LST00067 Checked By JDP

4/6/2018

LANDSCAPE PLAN

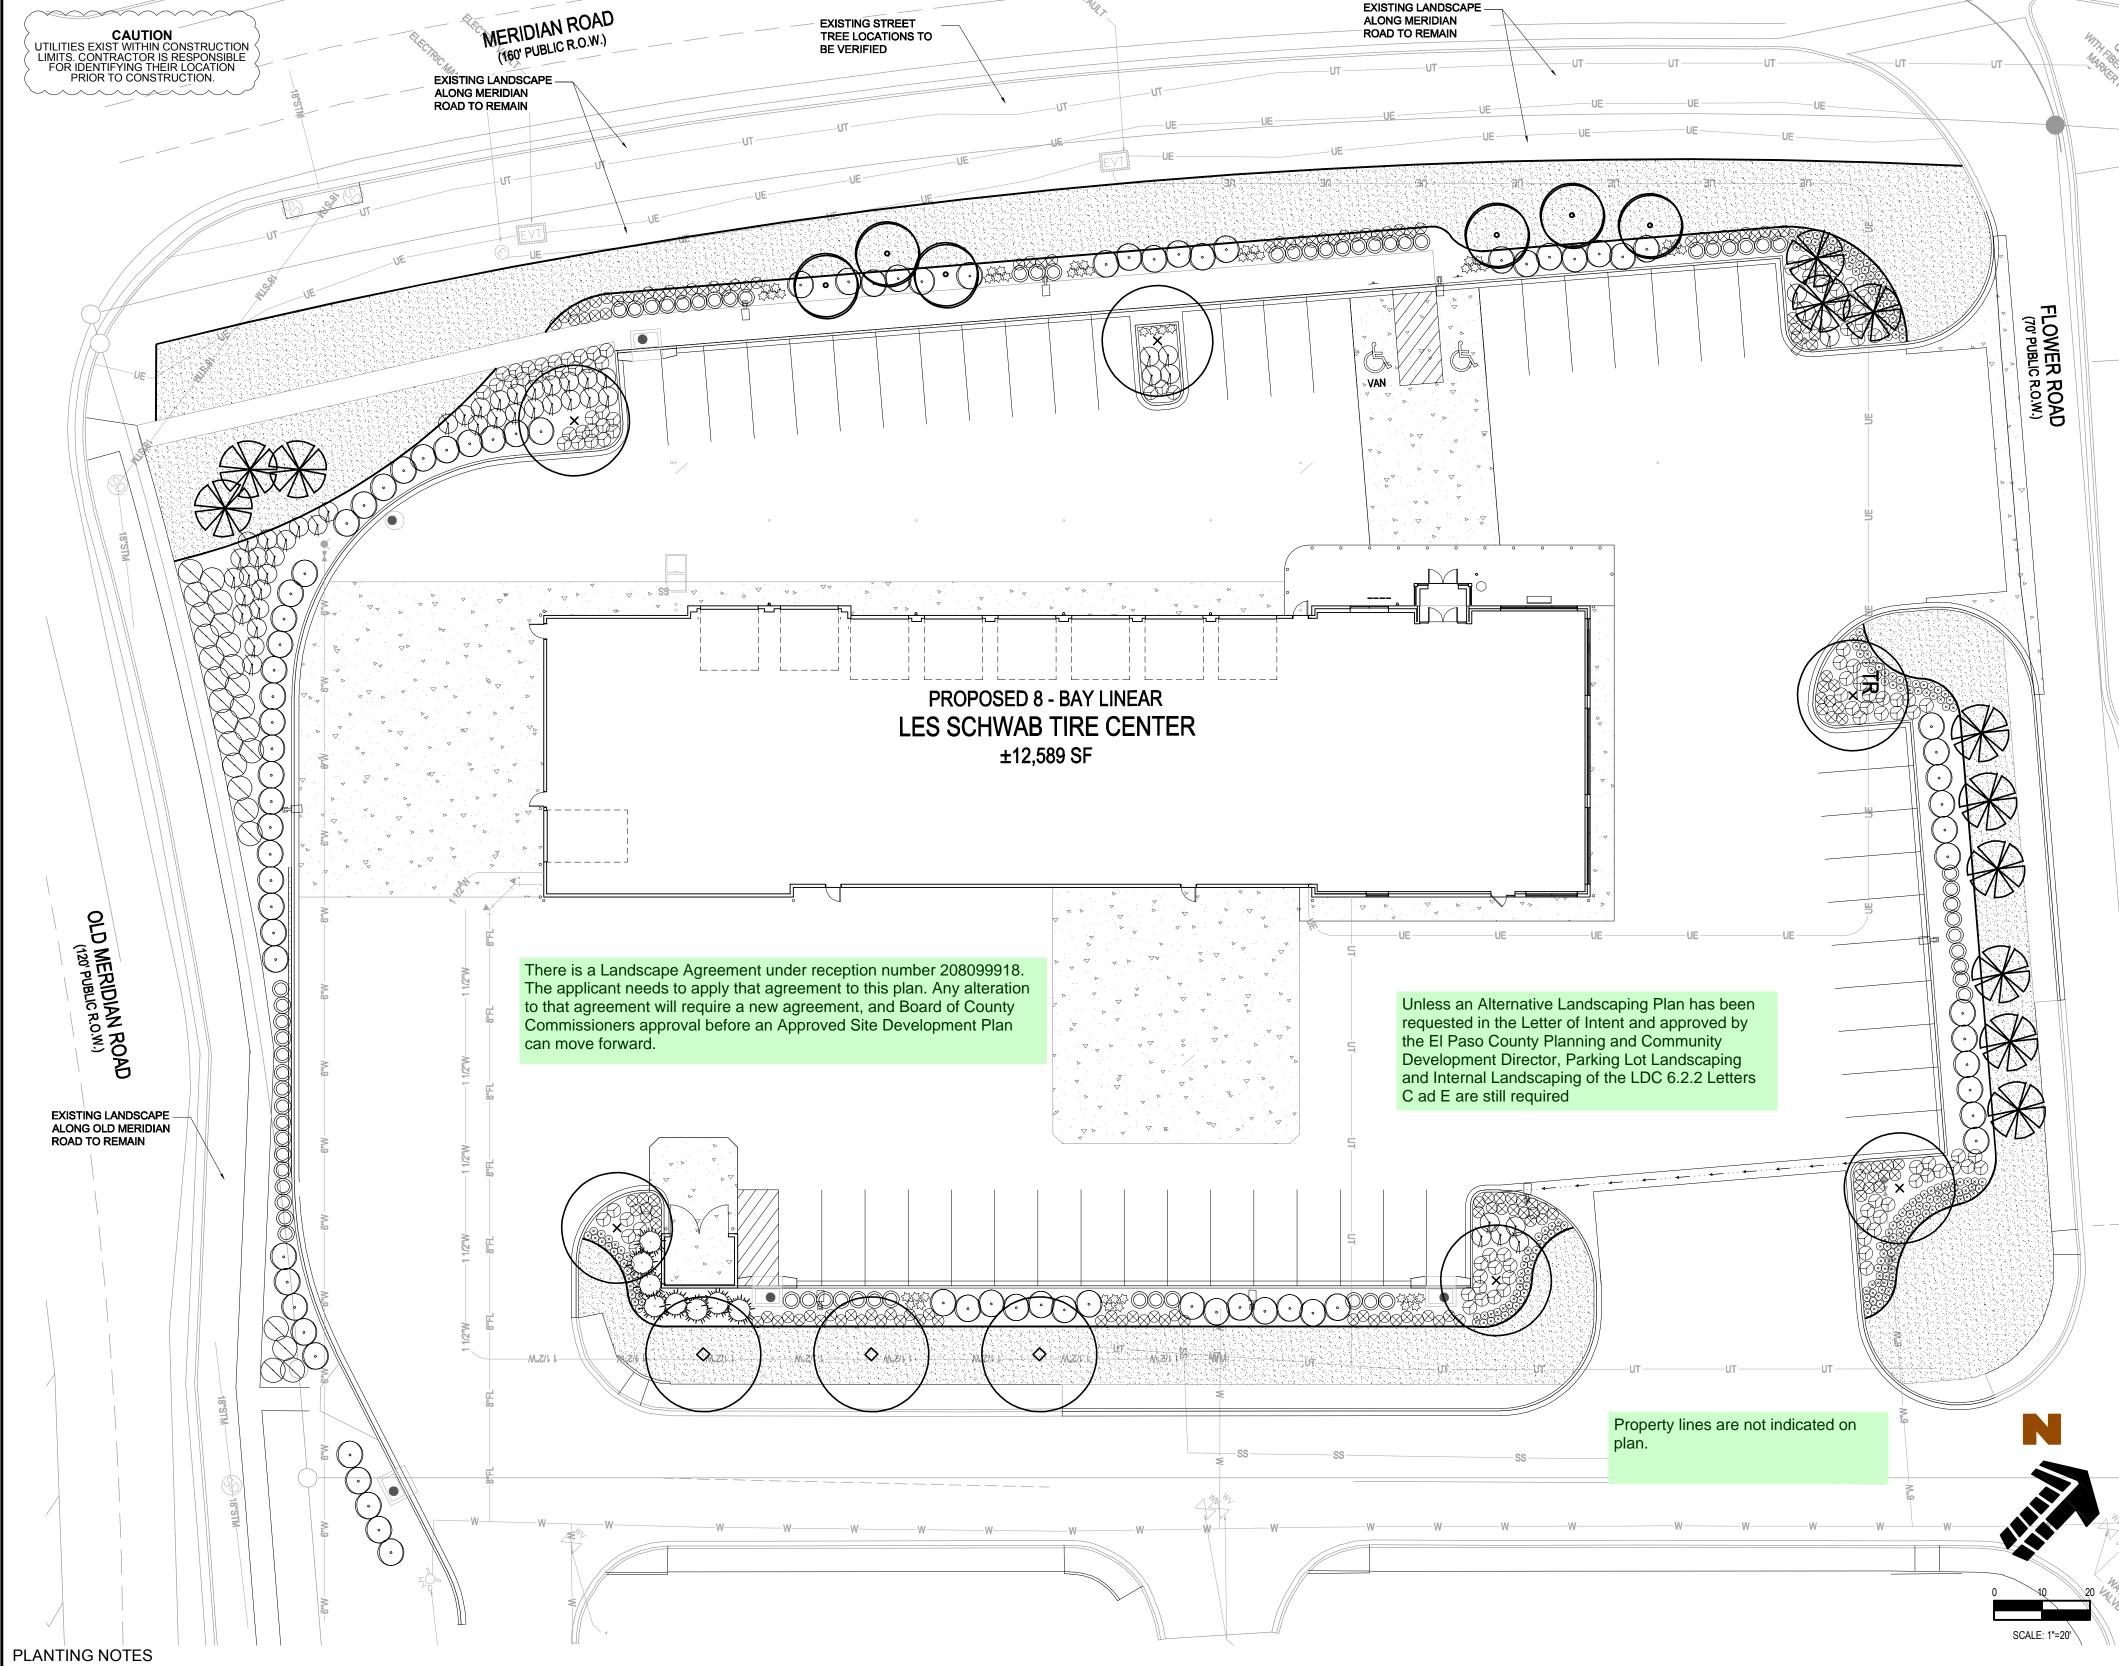
Property lines are not indicated on plan.

Unless an Alternative Landscaping Plan has been requested in the Letter of Intent and approved by the El Paso County Planning and Community Development Director, Parking Lot Landscaping and Internal Landscaping of the LDC 6.2.2 Letters

C ad E are still required

There is a Landscape Agreement under reception number 208099918. The applicant needs to apply that agreement to this plan. Any alteration to that agreement will require a new agreement, and Board of County Commissioners approval before an Approved Site Development Plan can move forward.

There should also be a column of how many are required by LDC 6.2.2
